**PROPOSED DEVELOPMENT – JACK STRAW’S CASTLE – APPLICATION RESPONSE
INTERNAL DAYLIGHT AMENITY TO PROPOSED UNITS**

Project: Jack Straw's Castle
London

Title: Room Layouts and ADF Results
Proposed Scheme
(Updated Basement)

Extract from Drawing Reference: P1306/I/06 – Internal Daylight Assessment

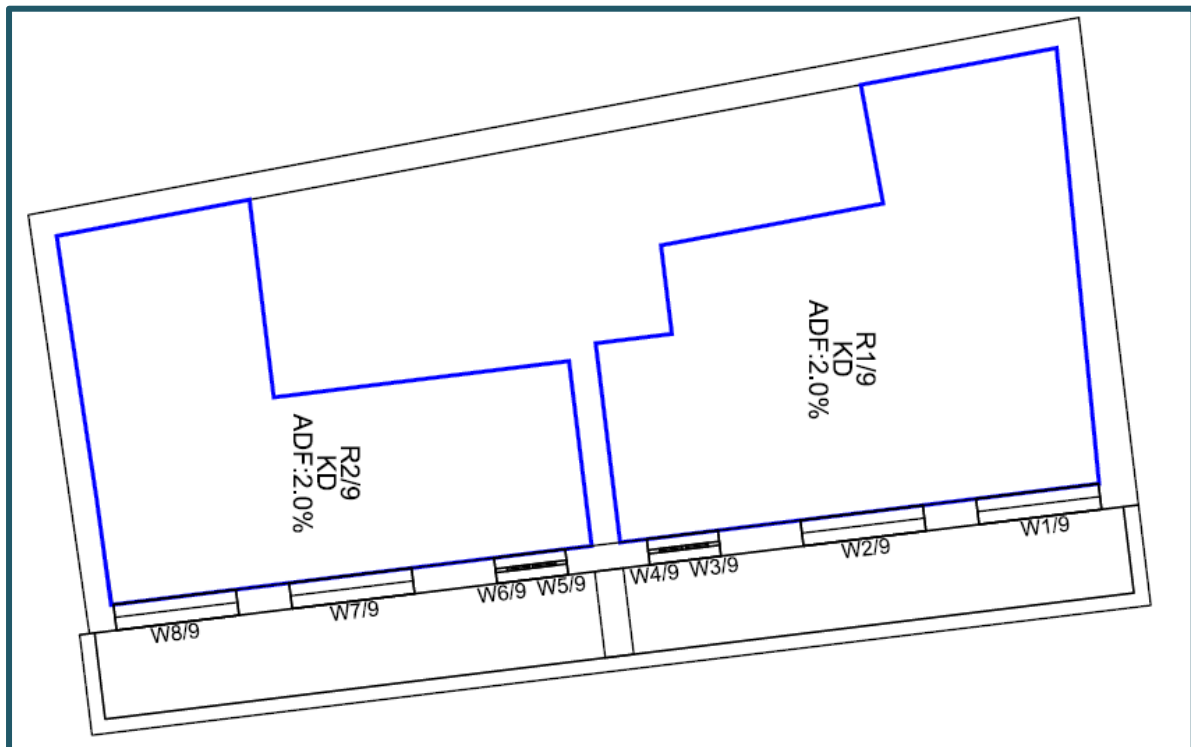
Further to the Case Officer’s comments in relation to the internal daylight amenity of the Kitchen/Dining Room units we have undertaken a revised assessment to illustrate a space that achieves an Average Daylight Factor (ADF) of 2%.

The assessment is based on the updated floor plan supplied by Quinlan Terry Architects. In order to achieve the 2% ADF as shown below, the lightwell has had to be increased by 150mm, and, implemented pantries to both rooms to reduce the overall size of the room which subsequently improves (on paper) the ADF.

We would maintain that the ADFs achieved in the earlier assessment will have still provided reasonable levels of daylight within the Kitchen/Dining Rooms. It is reminded that the BRE Guidelines are designed to help not constrain a designer. The advice given is not mandatory, and it should not be seen as an instrument of planning policy. Although it gives numerical guidelines, these should be interpreted flexibly since natural lighting is only one of many factors in site layout design (see paragraph 1.6, page 1 of the BRE Guide 209).

Whilst a 2% ADF is 'BRE compliant' for a Kitchen, we would encourage that a 1.5% ADF is still acceptable within this locality and indeed the wider urban grain. The Kitchen/Diner did very well to achieve such a high ADF given the large internal floor plate. We would submit that a larger floor plate achieving a 1.5% ADF would be more desirable than a smaller floor plate achieving a 2% ADF.

In reality, the best light levels will be achieved at the front of the room, whereas the rear of the rooms which have now been replaced with a Pantry would have received low levels of daylight in any event. The 'average' daylight factor has simply only improved because the assessable area is smaller.
